CITY OF ALBUQUERQUE

RE: Chavez Residence 7212 Osuna Rd. NE Grading & Drainage Plan Engineer's Stamp Date: 12/30/2024 Hydrology File: F19D040

Based upon the information provided in your submittal received 12/30/2024, the Grading & Drainage Plan is approved for Building Permit. Since this site is relatively flat and drains to the road, a pad certification is not needed for this project. Please attach a copy of this approved plan in the construction sets for Building Permit processing along with a copy of this letter.

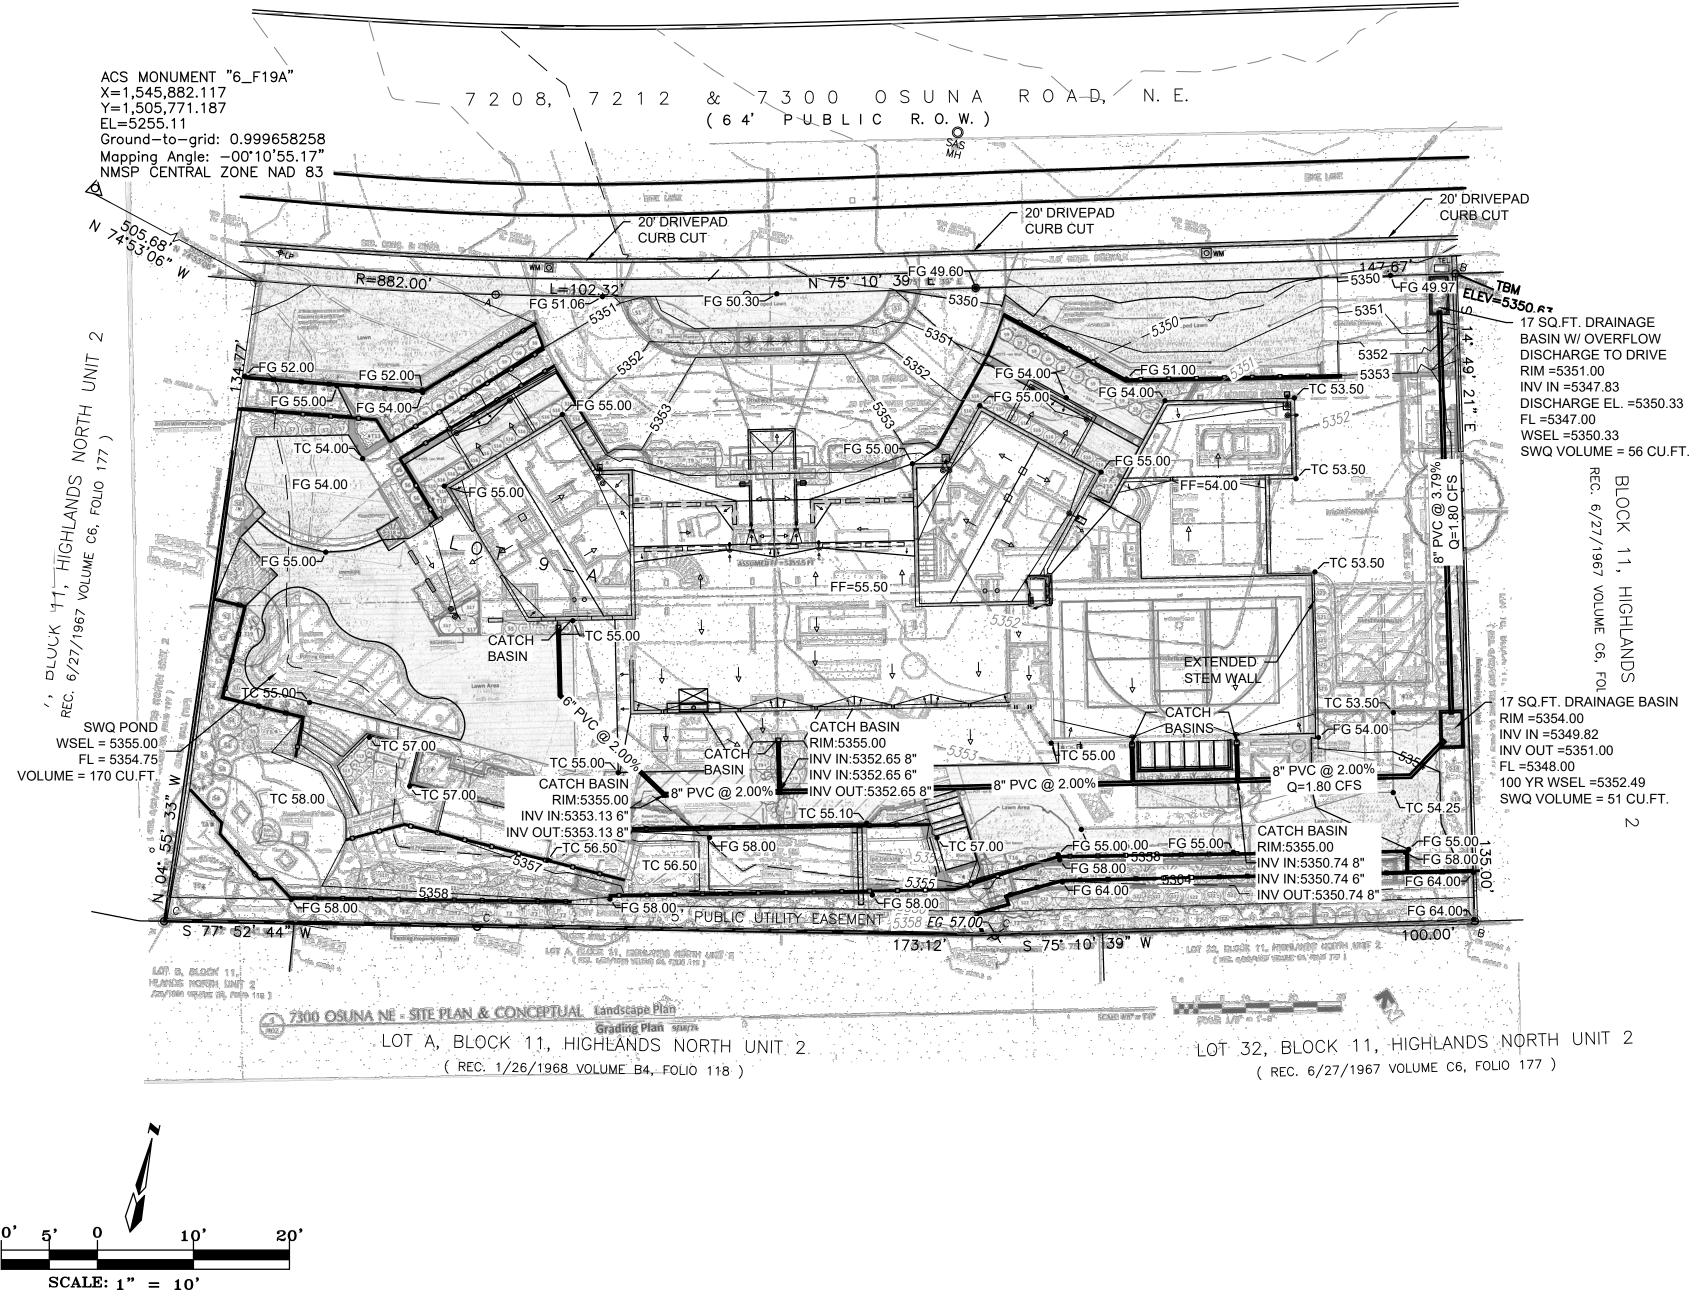
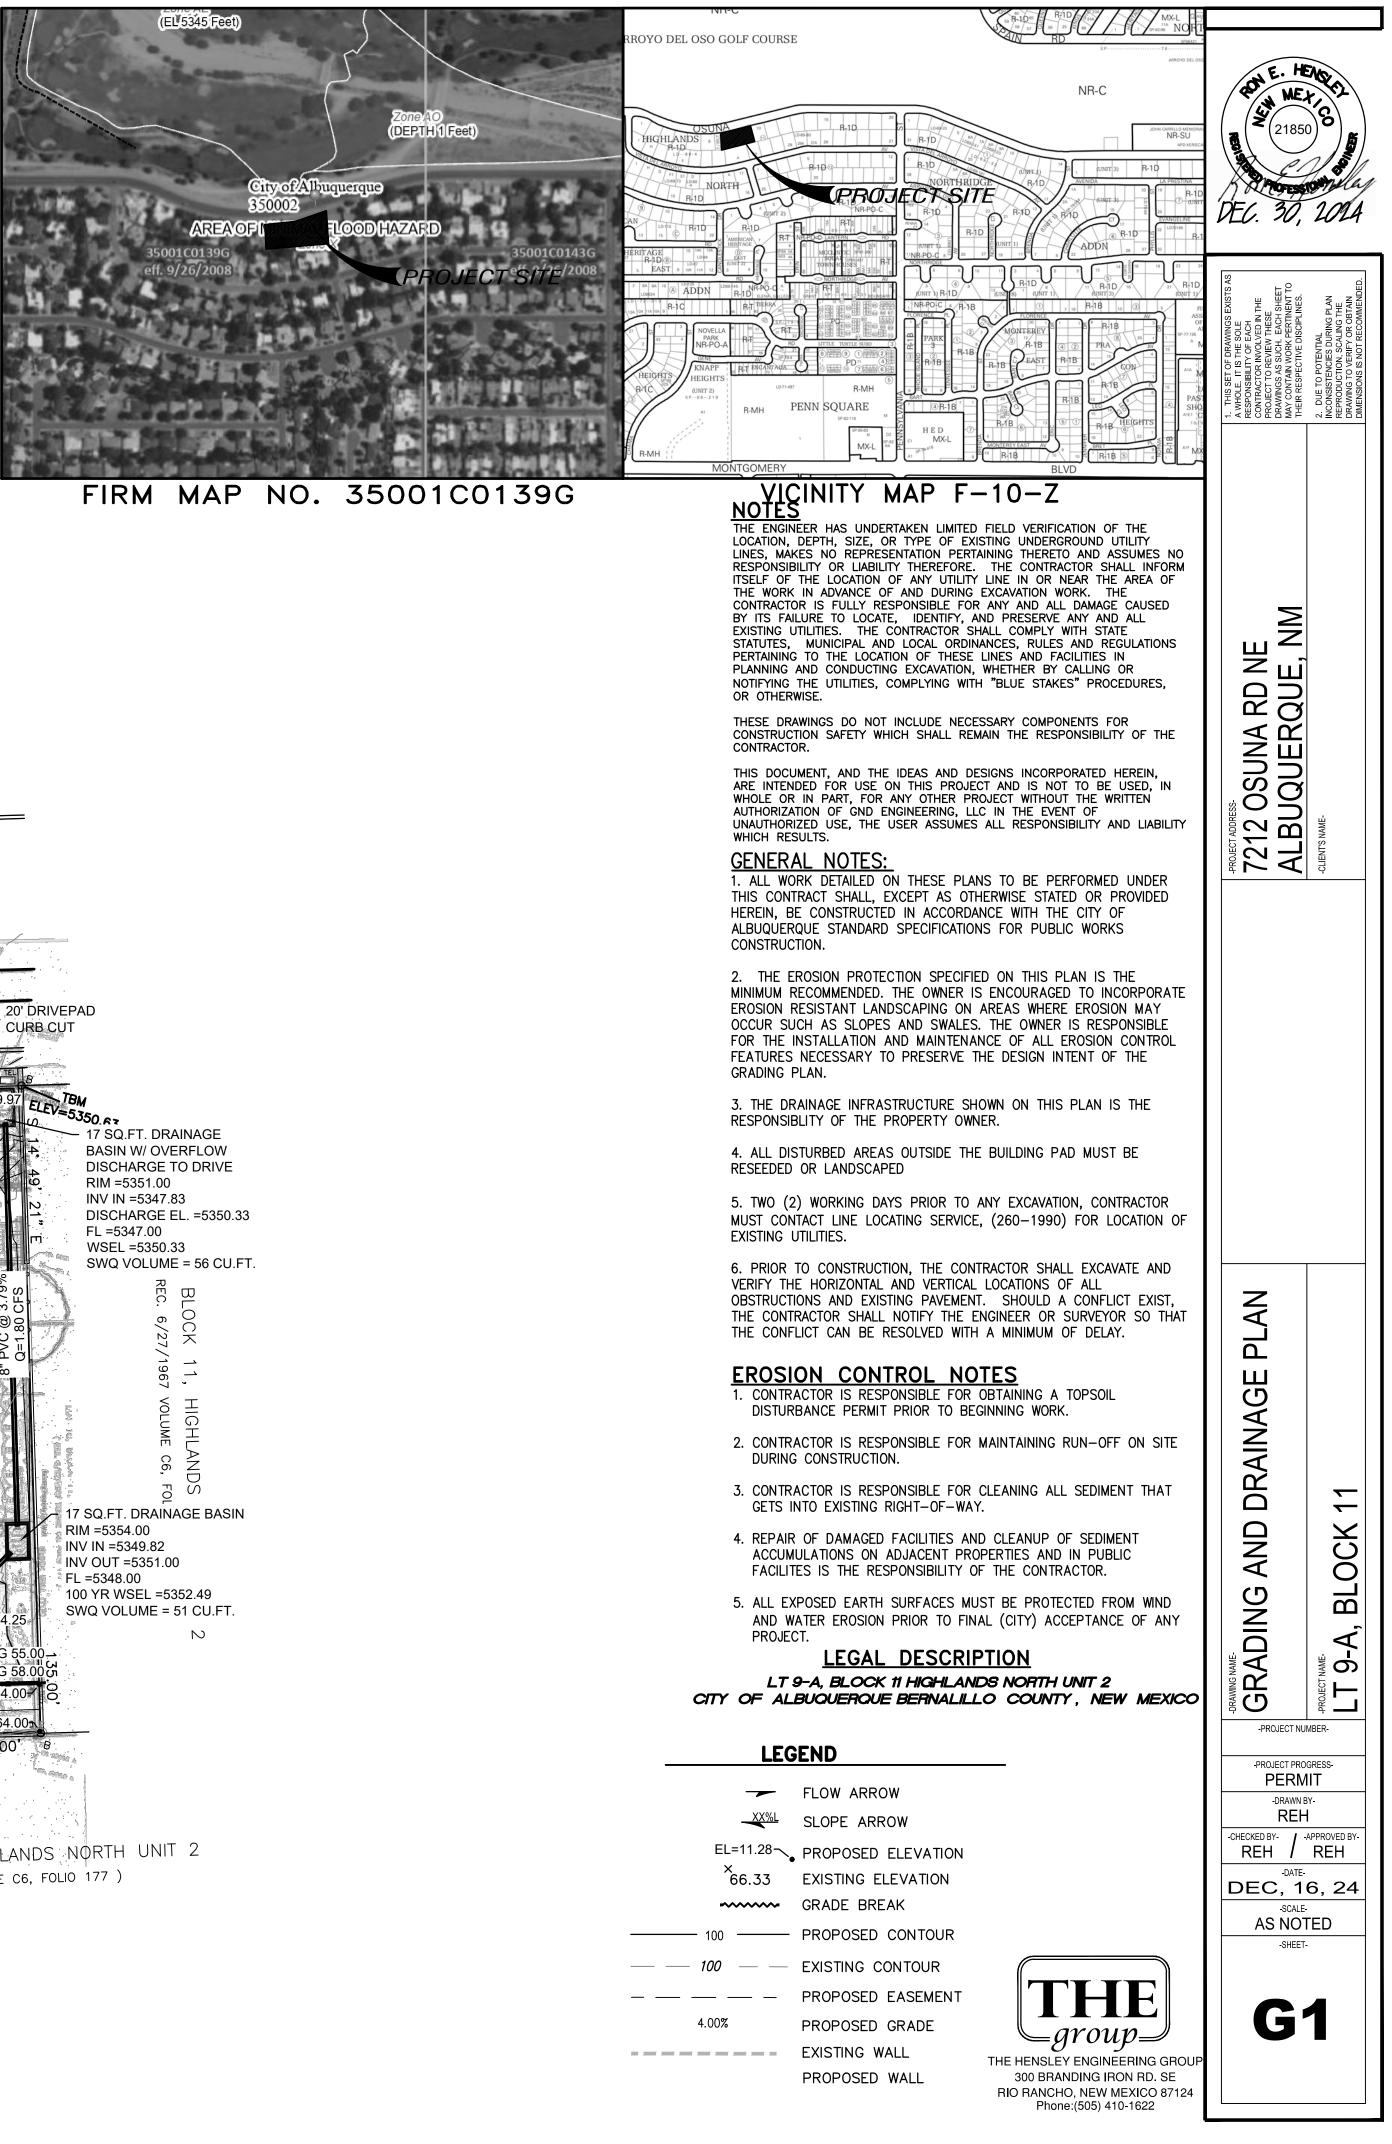
- 1. Engineer's Certification, per the DPM Part 6-14 (F): Engineer's Certification Checklist For Non-Subdivision is required.
- 2. Payment in Lieu (Amount = 123CF x \$6/CF = \$738,) of onsite management of the SWQV must be made. Take three copies of the treasury deposit slip to the Treasury and then include one copy of the paid deposit slip when resubmitting.
